<b>Docket Number:</b>	24-OPT-02
<b>Project Title:</b>	Compass Energy Storage Project
<b>TN #:</b>	258090-1
<b>Document Title:</b>	Data Request Response #1_Part I
<b>Description:</b>	N/A
<b>Filer:</b>	Erin Phillips
<b>Organization:</b>	Dudek
<b>Submitter Role:</b>	Applicant Consultant
<b>Submission Date:</b>	7/26/2024 8:29:44 PM
<b>Docketed Date:</b>	7/29/2024

CEC Data Request Response No. 1

# Compass Battery Energy Storage Project

**CALIFORNIA ENERGY COMMISSION**

FIGURE 11  
DR TRANS-5. Truck Routes within 1-mile Radius of Project  
Compass Energy Storage Project

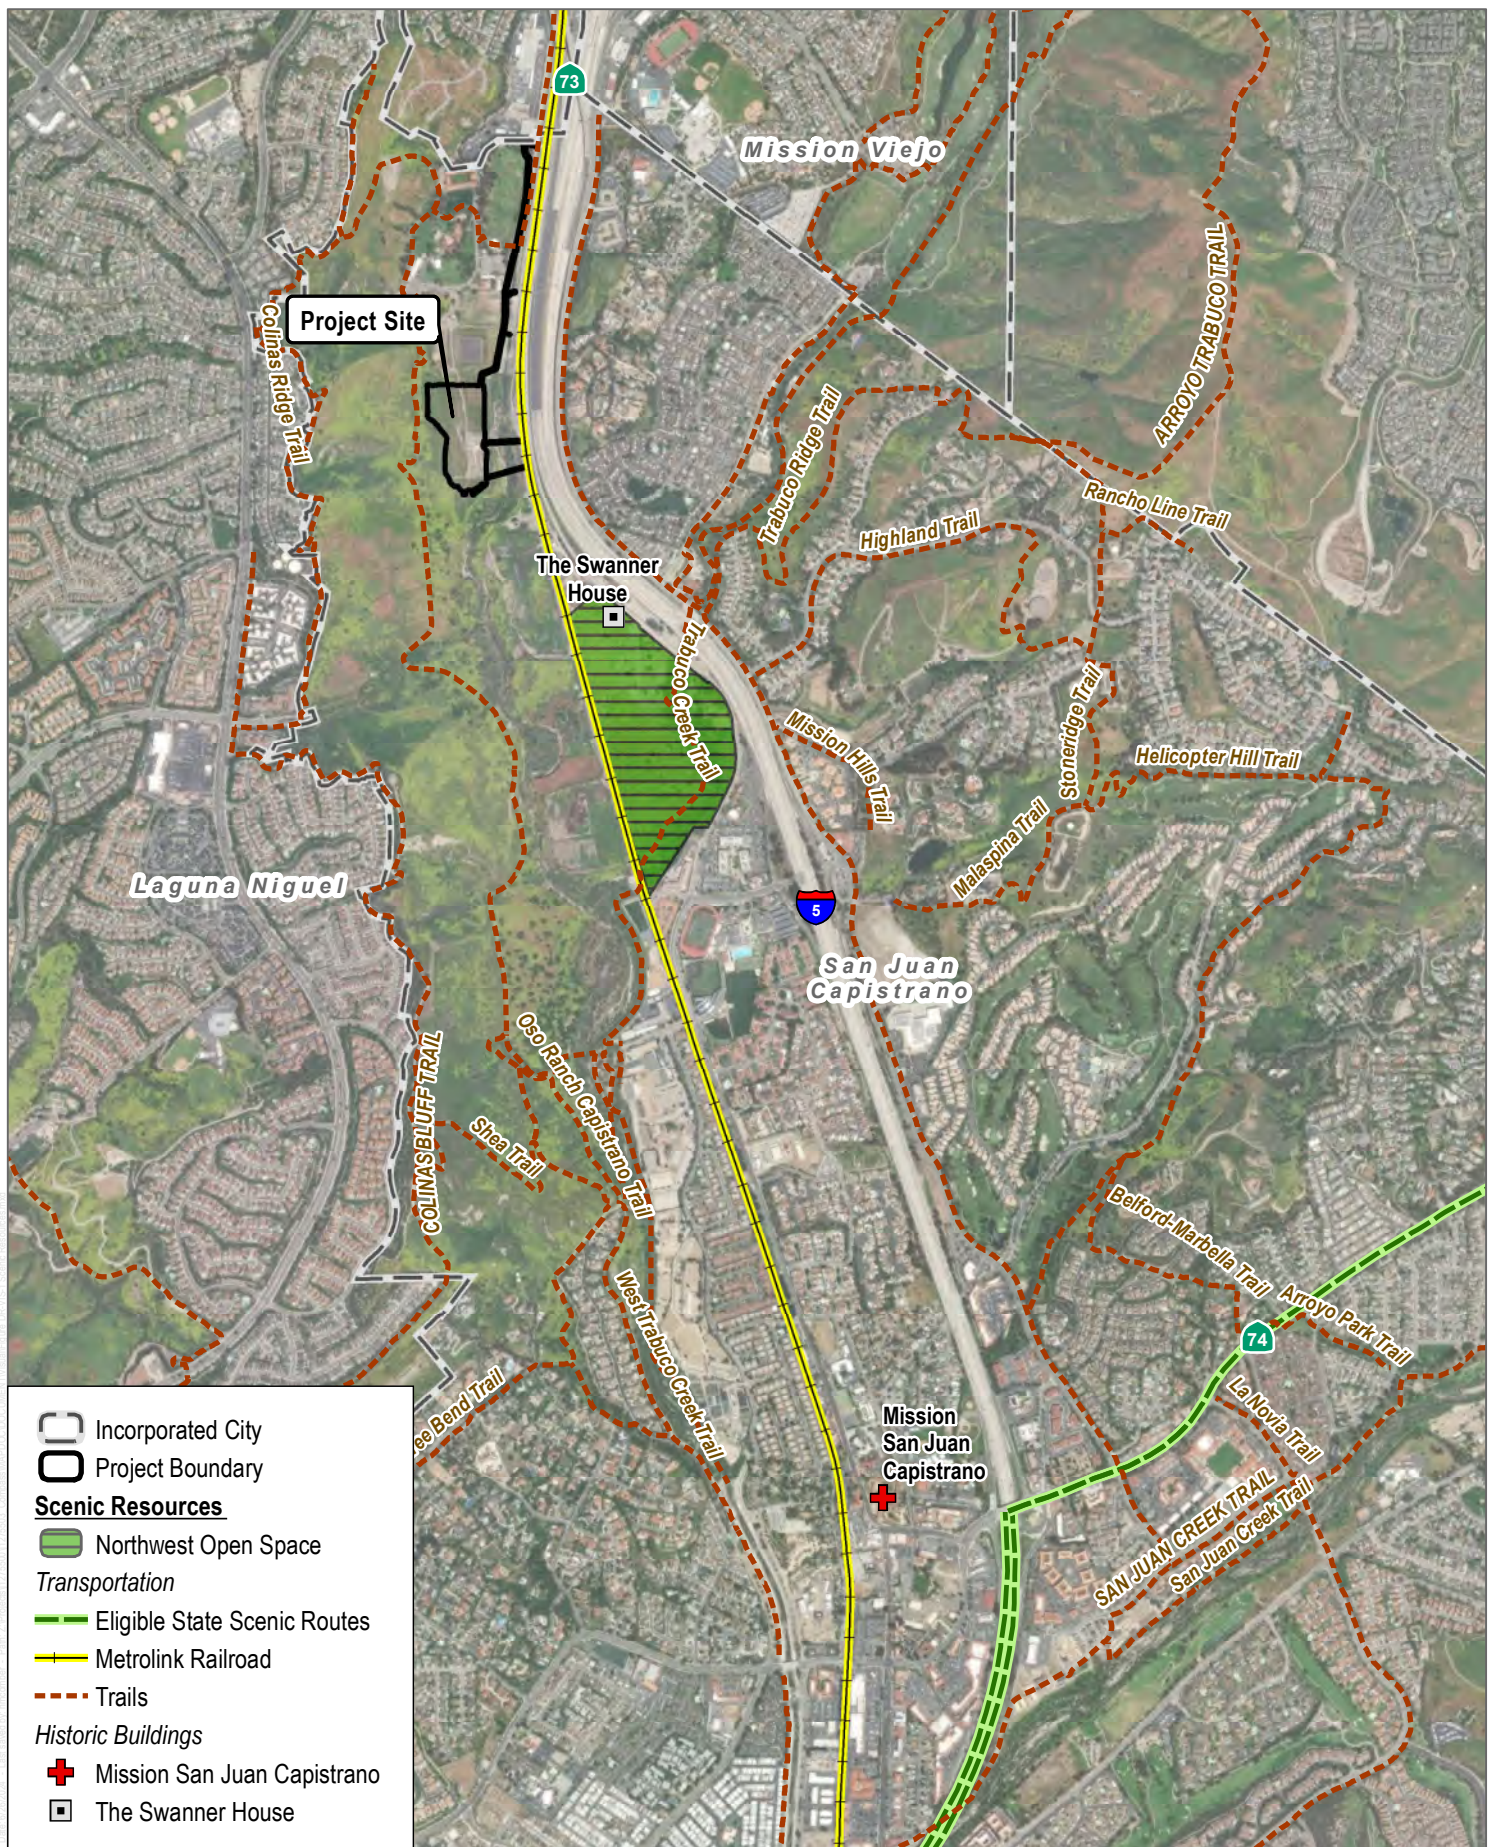
**Response:** A figure showing truck routes within a 1-mile radius of Project has been included as Figure 11. Per the City's Municipal Code, there are no weight restrictions on any roadway within 1 mile of the Project site. Per the City's Municipal Code,<sup>4</sup> the nearest roadways with weight restriction of commercial vehicle exceeding 12,000 pounds gross weight to the Project site are over a mile away as shown below:
